BulkTobac

To: Roanoke HeatX Conversion Kit Owners

Date: June 9<sup>th</sup>, 2003

Subject: HeatX FIRE HAZARD WARNING

### C. <u>CHECK THE CLEARANCE BETWEEN THE HEAT EXCHANGER AND THE</u> <u>ALUMINUM SHIELD HEAT SHIELDS</u>

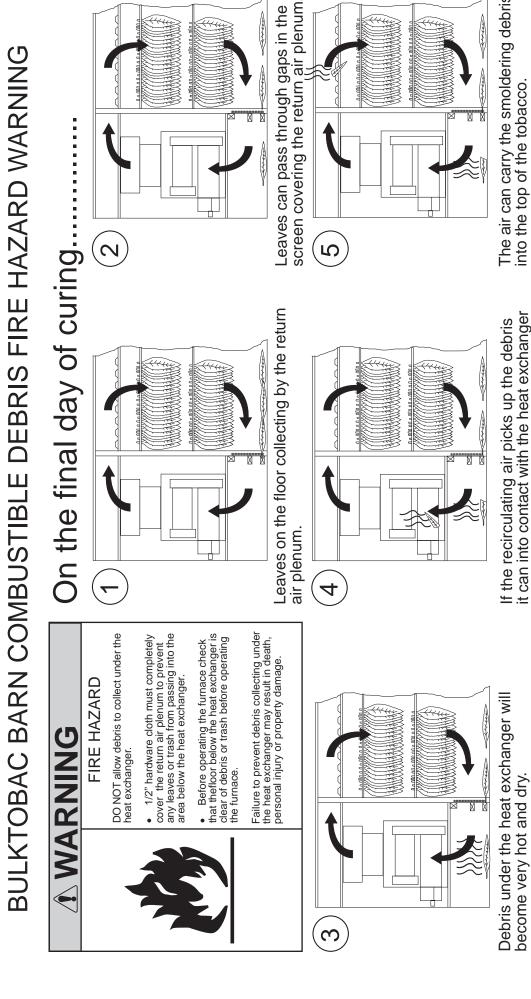
The clearance between the heat exchanger and the aluminum shield MUST be checked before each cure. The minimum recommended clearance is 1 \_". If the heat exchanger is too close to the heat shield (less than 1 \_" clearance) the shield can and will melt, leaving you without (any or proper) protection from a fire.

The "Z" spacers that support the aluminum shield must be correctly spaced. Even if the clearance is there and the Z brackets are not in the proper place the shield can be pulled in toward the heat exchanger by expansion due to heat. This can cause the shield to melt, leaving you without any protection from a fire.

The area behind the cabinet must be inspected to check that the wood 2 x 4's have been completely removed. If the shield melts (or worse yet is not even installed as we have seen in some cases) you have no protection and are subject to a fire. By removing the wood, even if the shield should become damaged, the possibility of a fire is considerably less than it will be if the wood remains in contact with the cabinet.

Please review the diagram below for the recommended layout.

- 1. If the Aluminum shield has at least 1 \_ " clearance and the Z brackets properly placed (24" apart / 12" to the right and 12" to the left of a vertical line in the center of cabinet) then removing or leaving the wood is up to you. Removing the wood is and was for an added margin of safety and in your best interest.
- If the Aluminum shield is installed correctly and the heat exchanger has less than 1
   \_" clearance then a spacer kit PN 61773100 (provided by BulkTobac for \$25.00
   each + shipping and handling Labor not included) must be installed for your safety.
   Please contact our Customer service department at (800) 438-4936 to order your kit.
- 3. If the "Z" spacers are incorrectly installed they must be reinstalled correctly. Correct installation is 24" +/- 1" apart.

# HEATX PROTECTIVE SCREEN INFORMATION SHEET

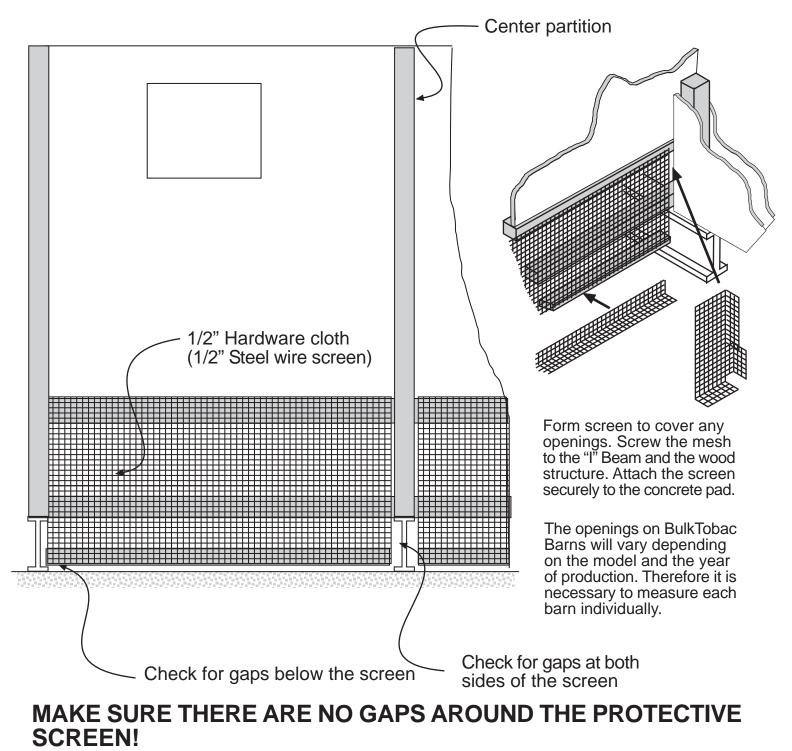
# COVER ANY OPENINGS USING STEEL 1/2" HARDWARE CLOTH TO PREVENT DEBRIS GETTING INTO THE AREA BELOW THE HEAT EXCHANGER. FAILURE TO PREVENT DEBRIS UNDER THE HEAT EXCHANGER CAN RESULT IN A FIRE.
